# Public Service Commission

July 23, 2018

The Reclamation Division has reviewed your concerns regarding your land located in the NW $\frac{1}{4}$  of Section 34, T146N, R88W, as outlined in your May 4, 2018 email. Your property is located off-permit and adjacent to Surface Coal Mining Permit NACT-9501 at the Coteau Properties Freedom Mine.

PreMine Topograhly, Landuse and Imagery above NW1/4 34, T146N, R88W

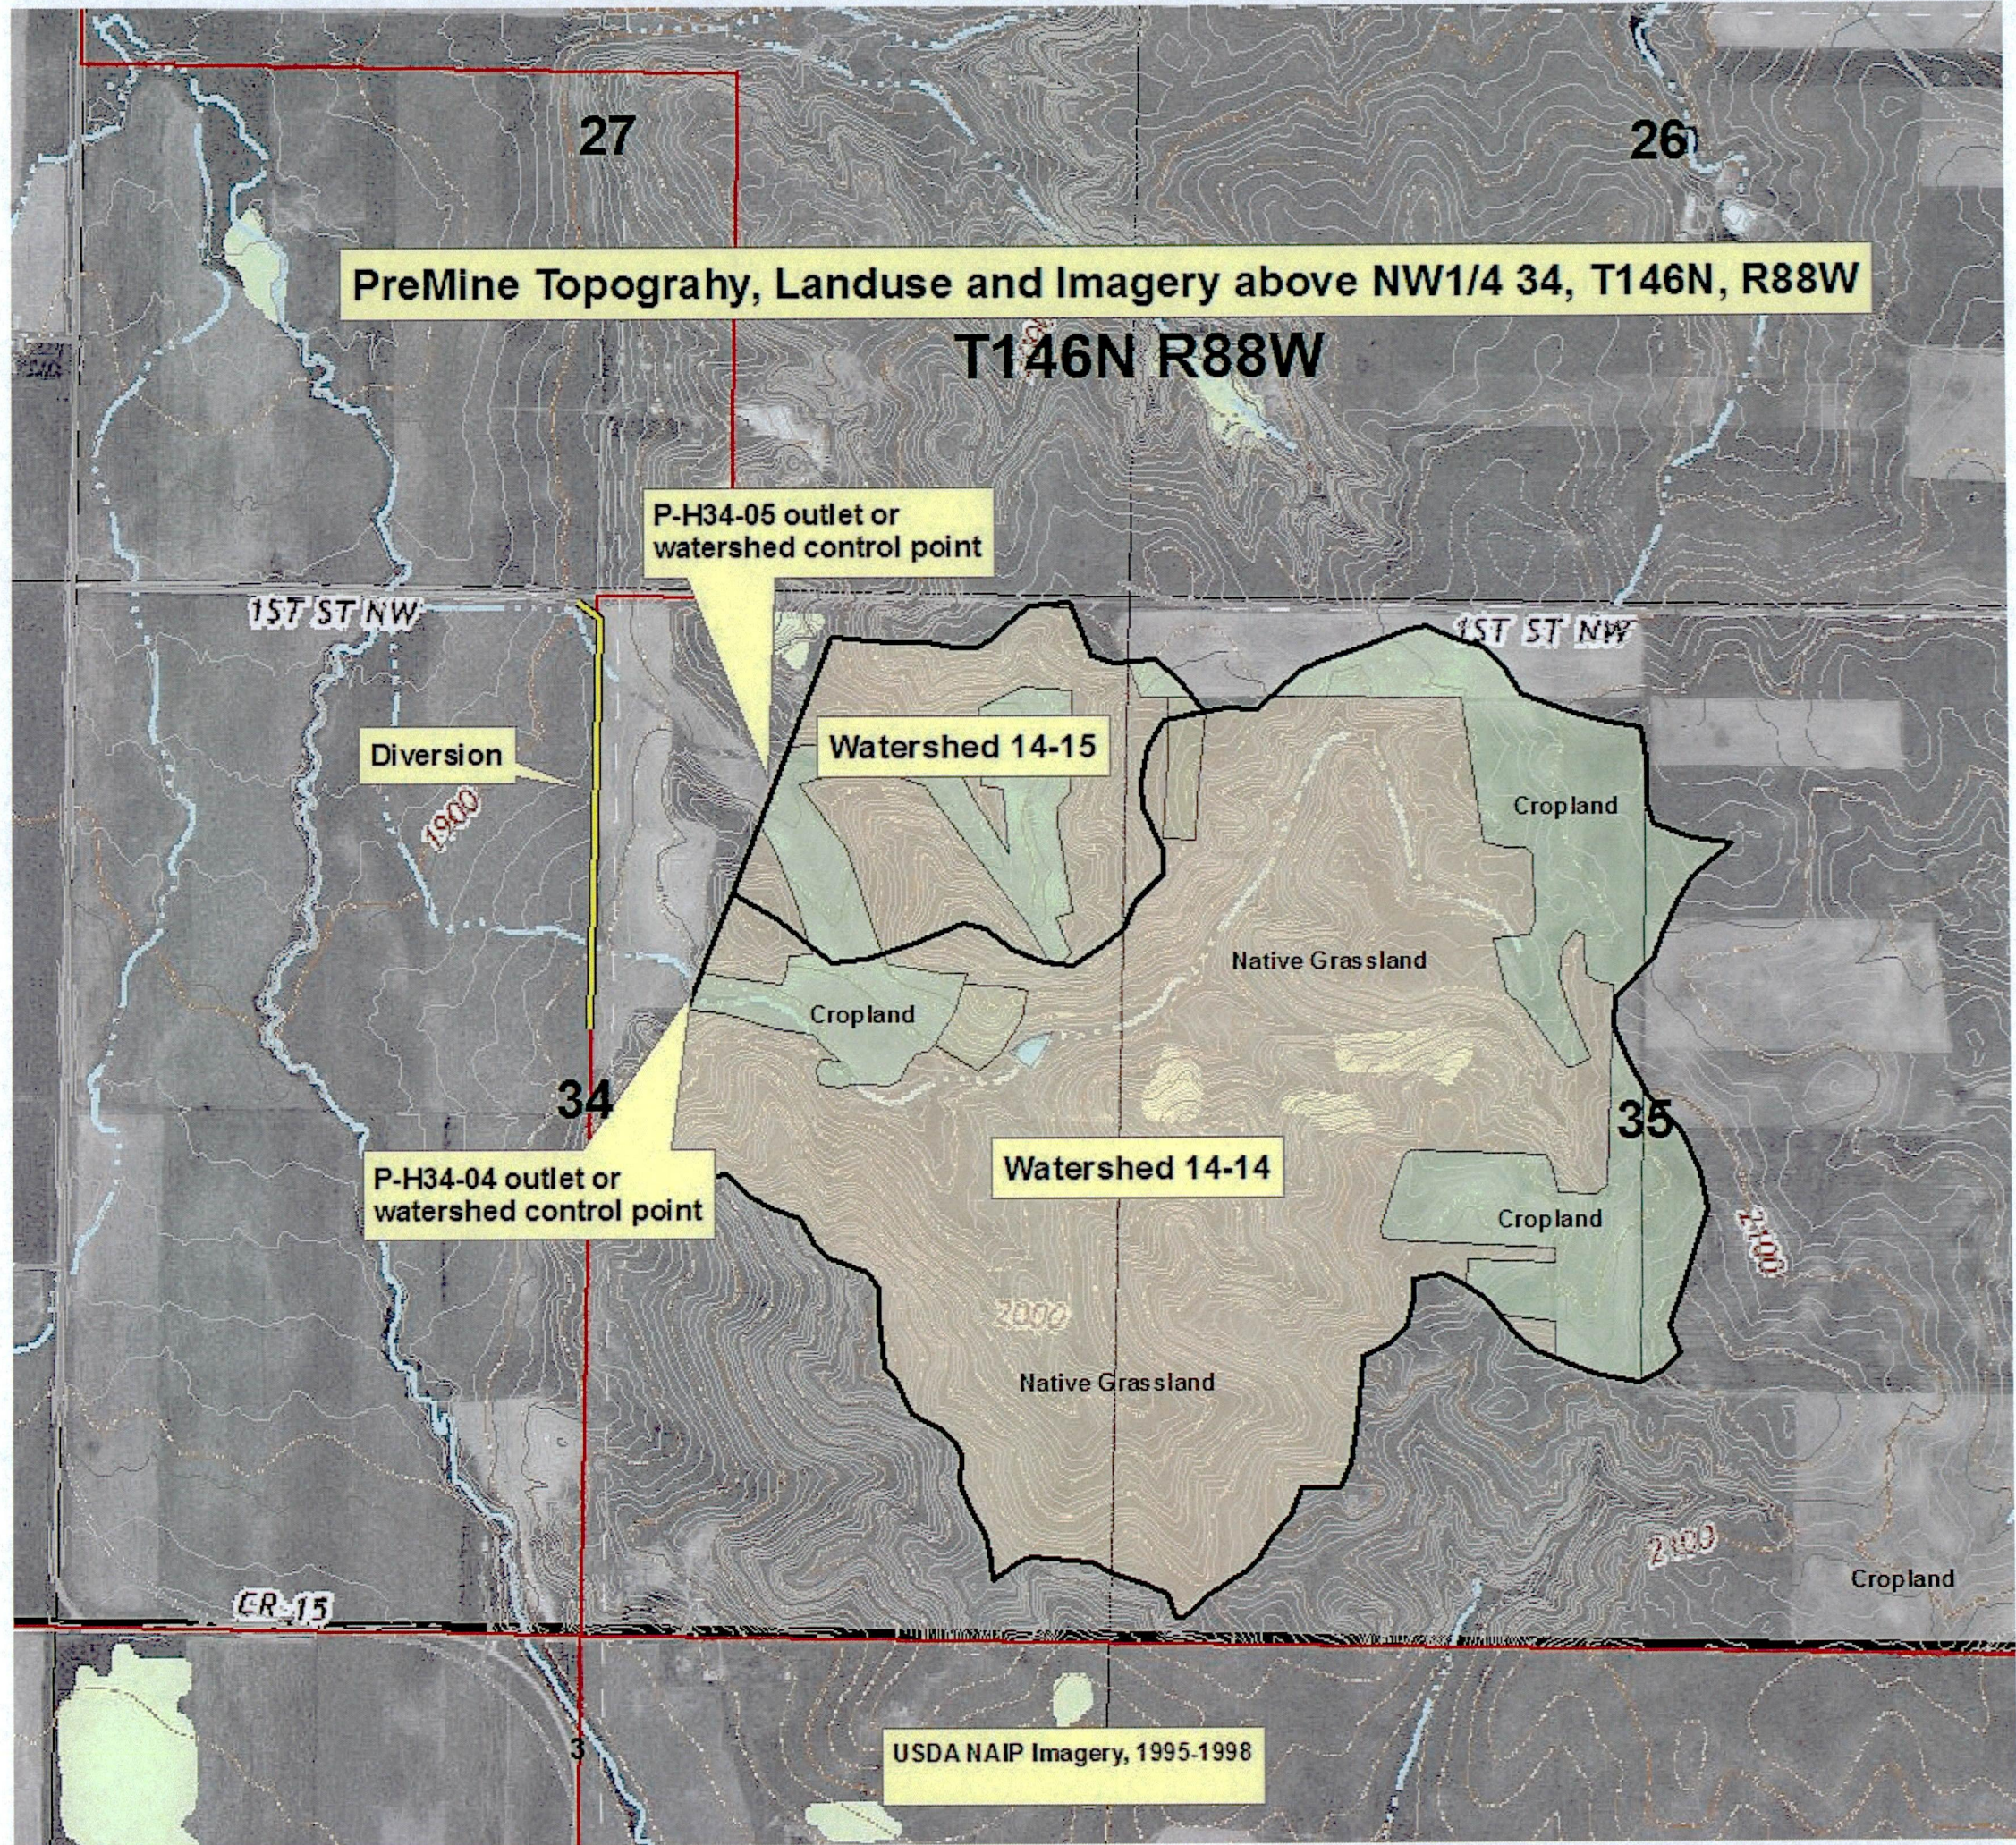
On August 28, 2007, Coteau submitted the application for Revision No. 30 to Surface Coal Mining Permit NACT-9501. This revision proposed changes to the postmine topography and watershed boundaries in the NE $\frac{1}{4}$  of Section 34. The size of watershed 14-14 (most of the area controlled by sediment pond P-H34-04) decreased slightly (5 acres smaller than premine) but the size of watershed 14-15 (most of the area controlled by sediment pond P-H34-05) was increased by 132 acres. The combined area of watersheds (14-4 and 14-15) increased by a total of 127 acres. Revision No. 30 also proposed some land use changes for the NE $\frac{1}{4}$  of Section 34 including changing the postmine land use of a portion of the watersheds from cropland to native grassland. Attached are maps depicting pre- and post-mine watersheds 14-14 and 14-15.

Our analysis shows that even though the total combined watershed size increased after reclamation, the expected total flow rates and volumes are less than the premine condition. This is due to a number of reasons but is primarily due to the reclaimed or postmine watersheds being less steep than the premine watersheds. The premine average slope of watershed 14-15 was 12.7% and the postmine average slope is 4.4%. In addition, the shallow and claypan soils that were common in the premine watershed were replaced with deeper, loamy soils with higher infiltration rates. In addition, there is less cropland and more native grassland in the reclaimed watershed than in the premine watershed. The perennial native grassland vegetation generally has a lower runoff potential than cropland.

PostMine Topograhpy, Landuse and Imagery above NW1/4 34, T146N, R88W

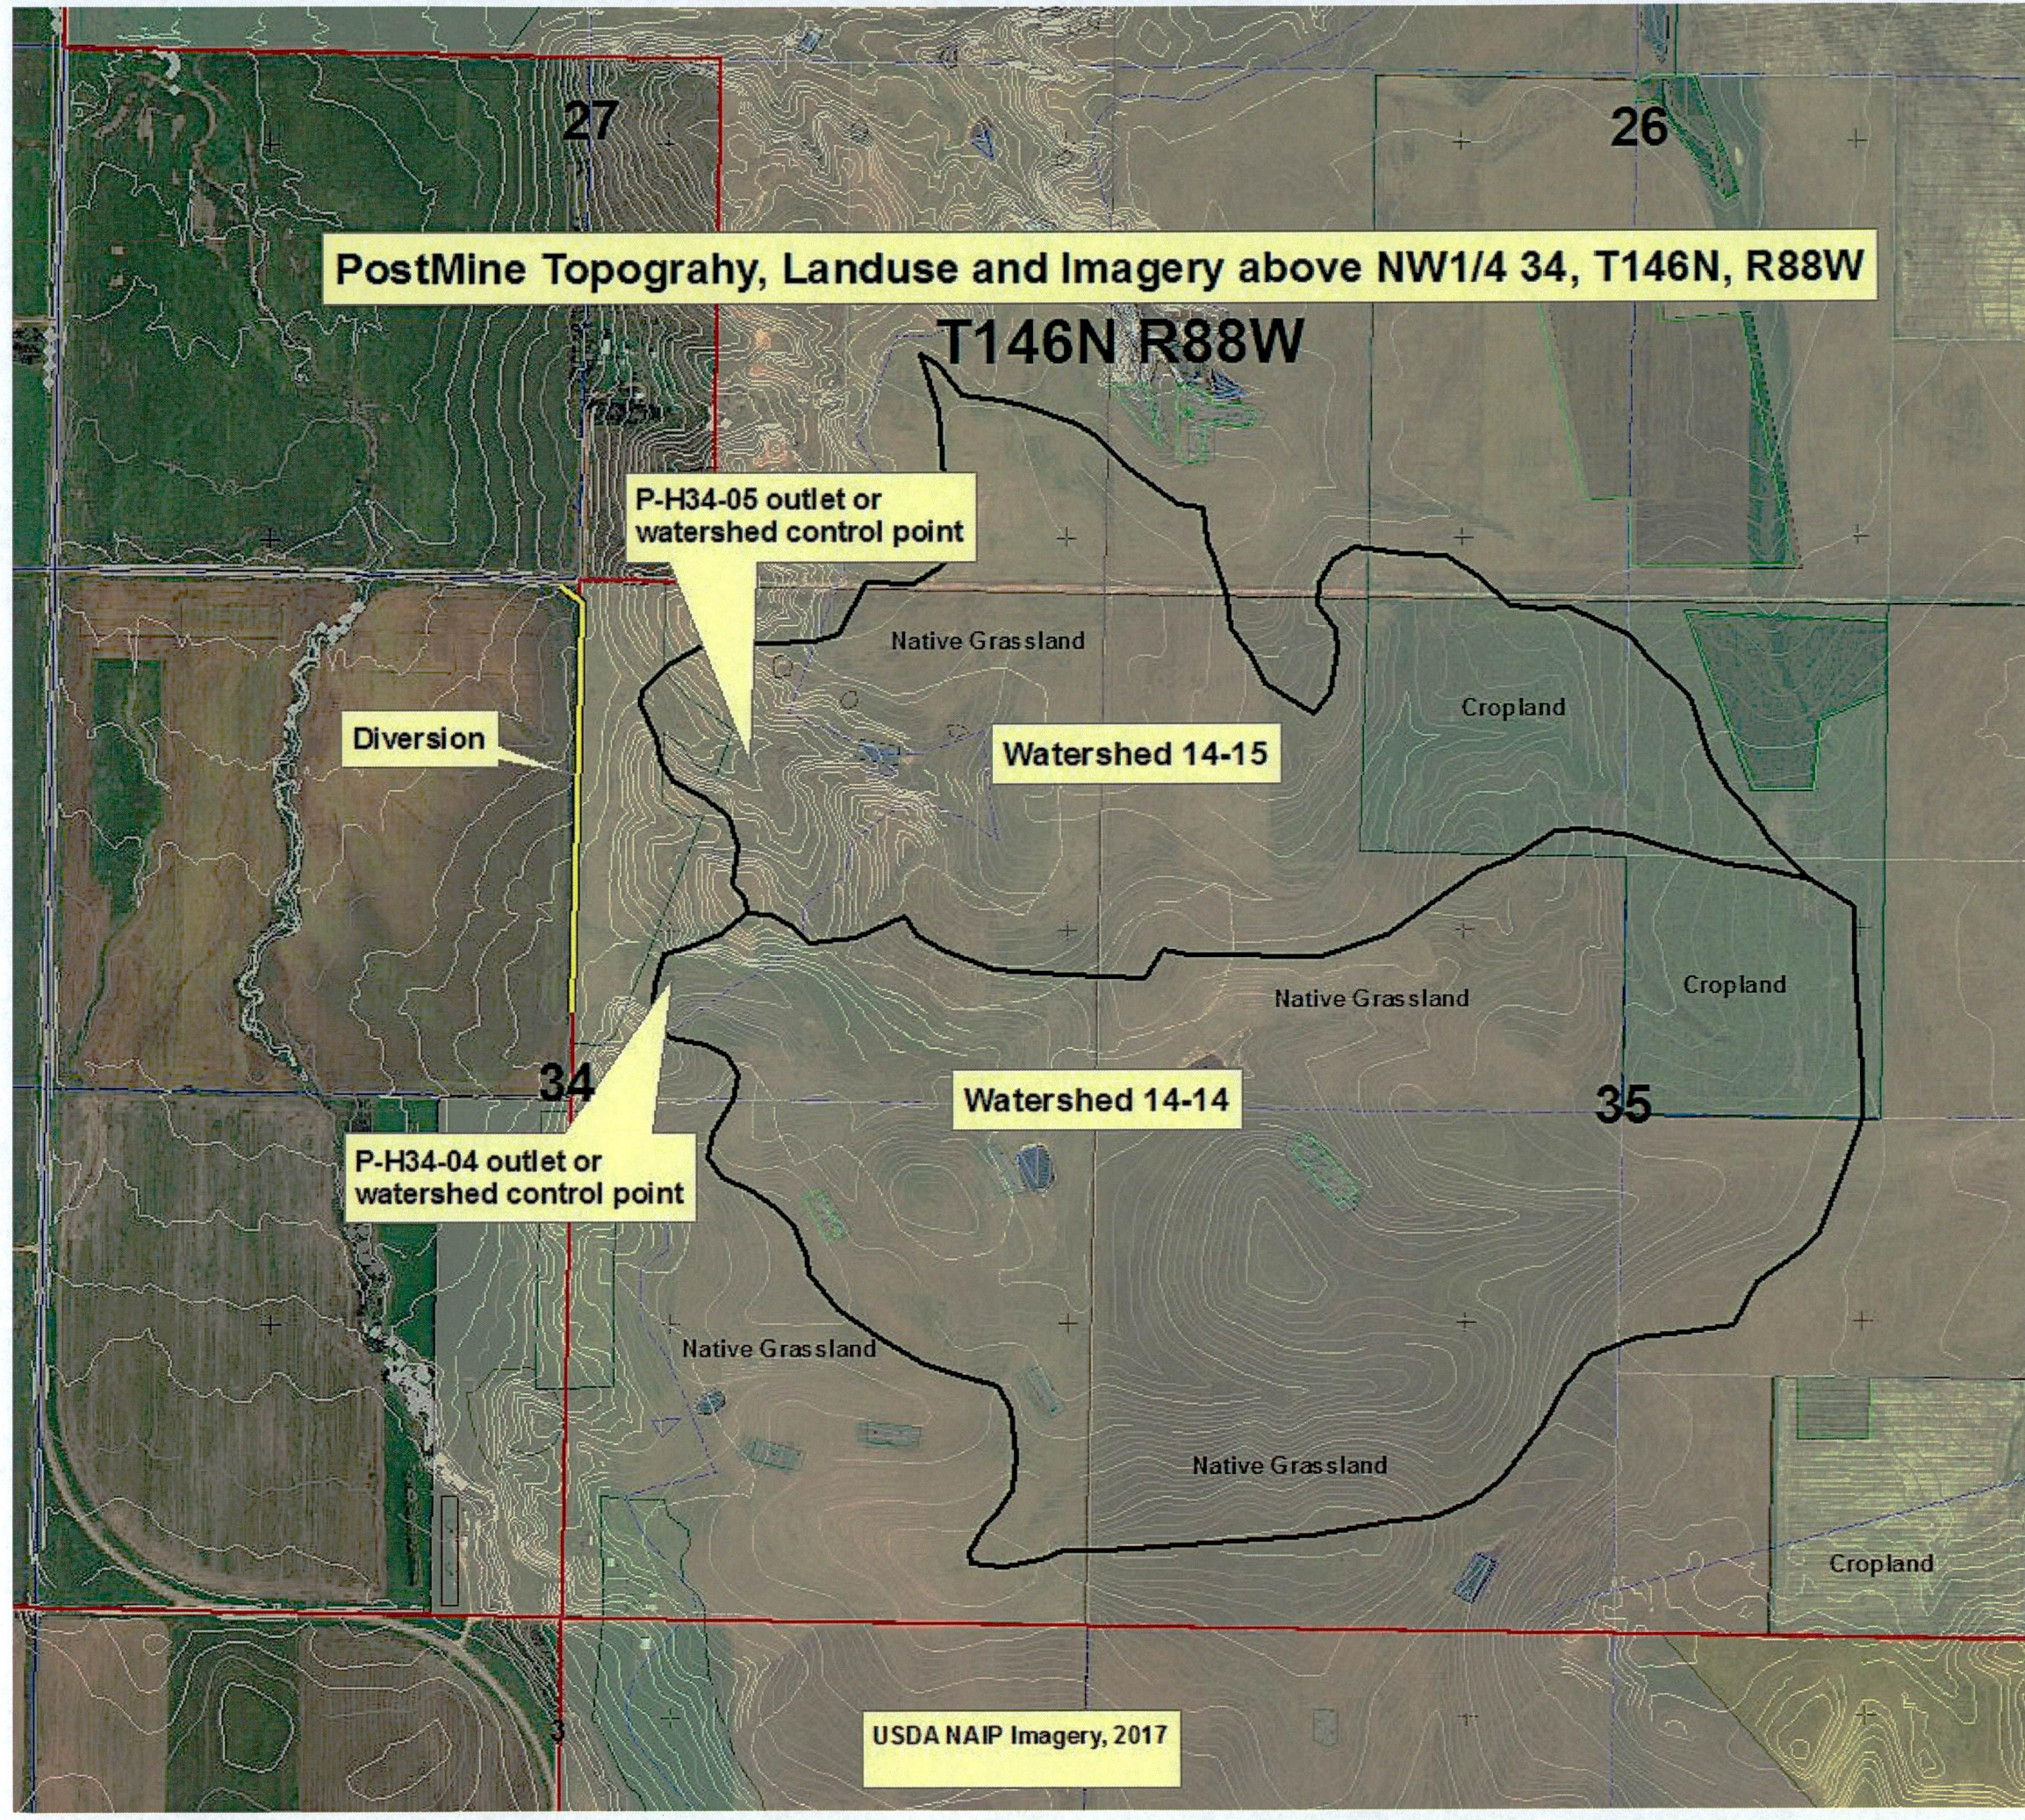
**Required Action:** During our reanalysis of the Probable Hydrologic Consequences (PHC), we noted the reclaimed grassland drainage channel for watershed 14-15 (within the permit area) enters the reconstructed diversion at a right angle and drops several feet in elevation over a very short distance. This configuration has resulted in erosion and maintenance problems in the past. The original drainage channel flowed in a more northwesterly direction and entered the existing diversion near the northeast corner of the NW¼ of Section 34. We will require Coteau to re-route this drainage channel in a more northwesterly manner, similar to how it existed prior to mining. This will result in a more stable configuration and much of the drainage from watershed 14-15 will flow almost directly into the east-west reconstructed road ditch rather than flowing into the north-south reconstructed diversion. As a result of this reconfiguration, most of the drainage from watershed 14-15 will "bypass" your property with the exception of the south road ditch. Most of this "reconfiguration work" will take place within the permit area; however, the point at which the reconfigured drainage channel will enter the reconstructed diversion is located on your property and we encourage you to work with Coteau to accommodate the reconfiguration of this drainage channel.
